S/S "HELLE" Plan. Ppt 46, 8971.

ÄNDRAD ENL. KLASSEN, FRÅN LLOYD'S N 25-9-52

AB CARLSONS VARV	
S/S HELLE	
BUNKERTANK	
124	1008
Lloyd's Register Foundation

Conversion of side
bunkers into fuel
oil tanks.

PLAN AV HUVUDDÄCK.

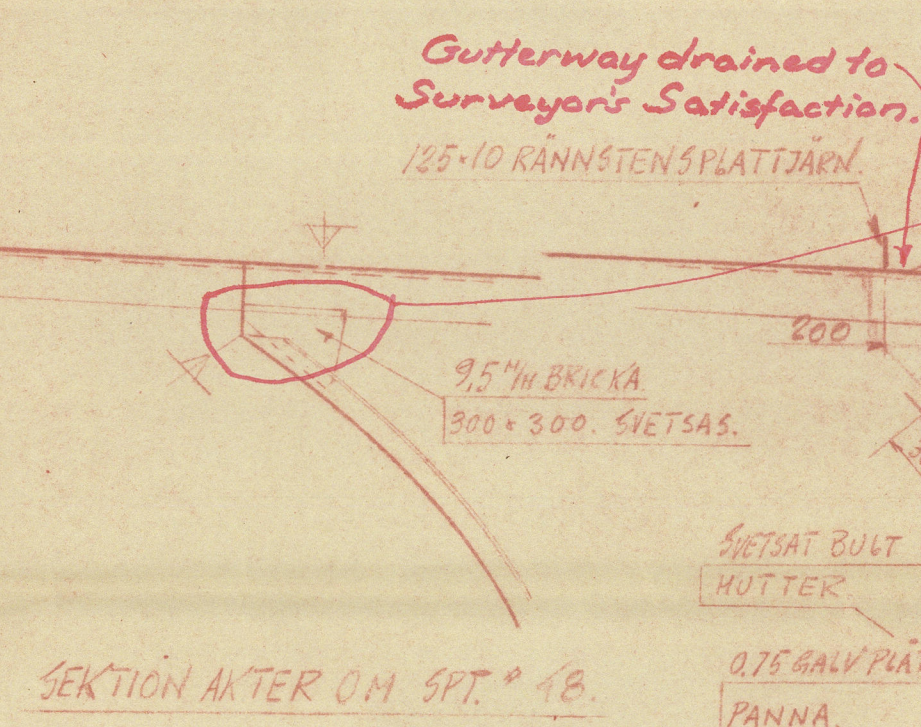
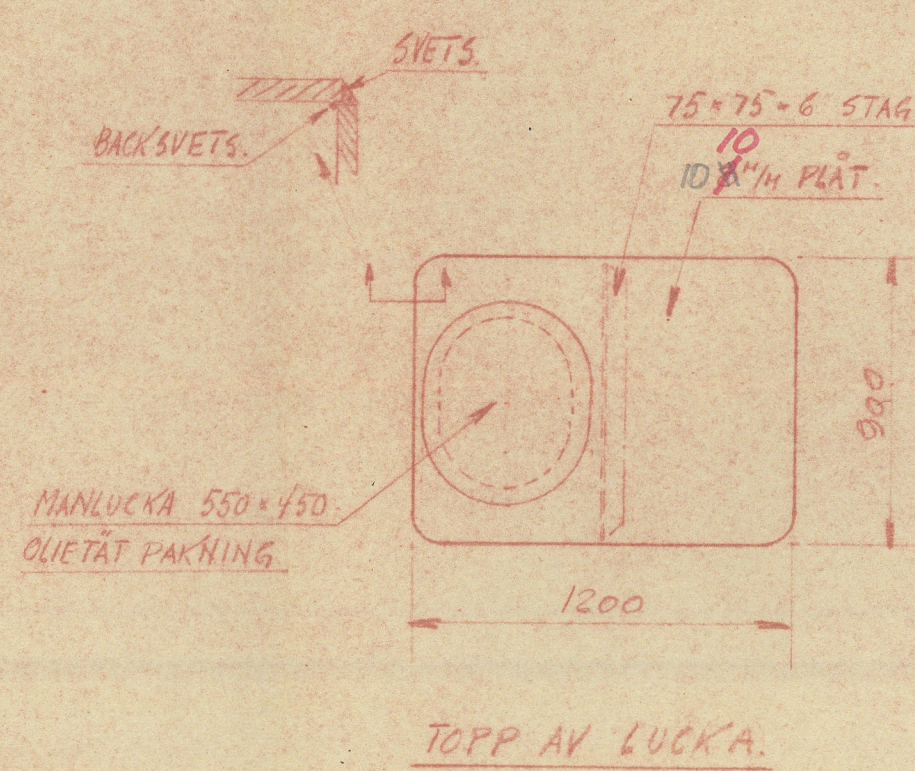
MELLAN BEFINTLIGA STAG PÅ LÅNGSKEPPSSKOTTET OCH TVÄRSKEPPSSKOTTEN INSÄTTAS NYA STAG, SOM SVETSAS FAST.

KOLLUCKORNA I LÅNGSKEPPSSKOTTET BORTTAGES OCH HÅLEN IGENSÄTTAS.

KOLLUCKA AVRÄPAS OMEDELBART UNDER HALVRUNDJÄRN.

SEKTION GENOM BUNKERTANK SPT. 51

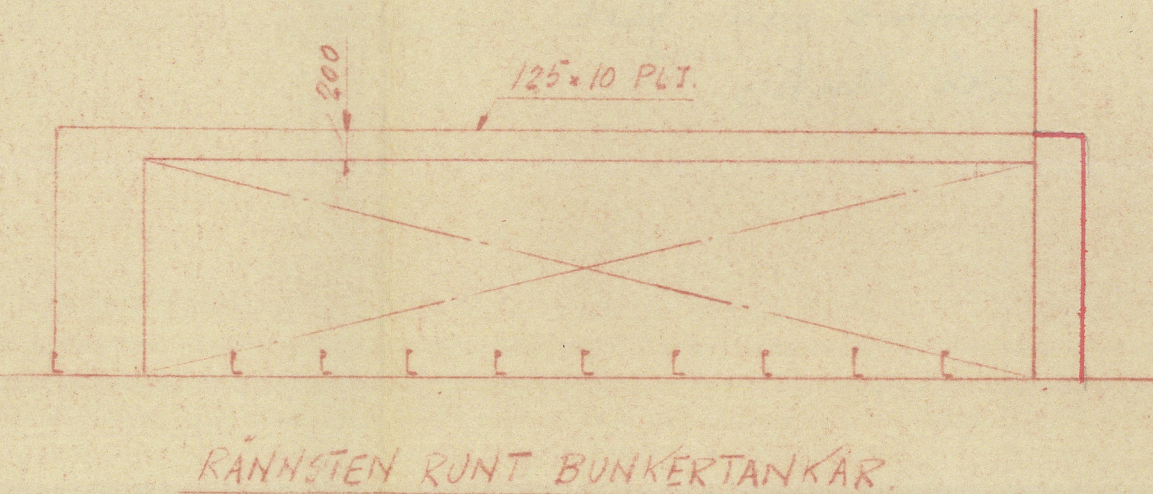
Double bottom under not to be used for fresh water

- Note:
- 1) Seams and butts, stiffeners and boundary bulkheads plating to be made O.T.
 - 2) Sparring to be fitted on bhd 53 in hold.

Deck plating in way of tank not to be less than 7.5 mm

Alternate intermediate rivets fitted between existing rivets or equivalent strengthening by welding.

The flash point of the oil fuel to be above 150°F. and the remaining requirements of Section 20 of the Rules 1952 to be complied with so far as they are applicable.
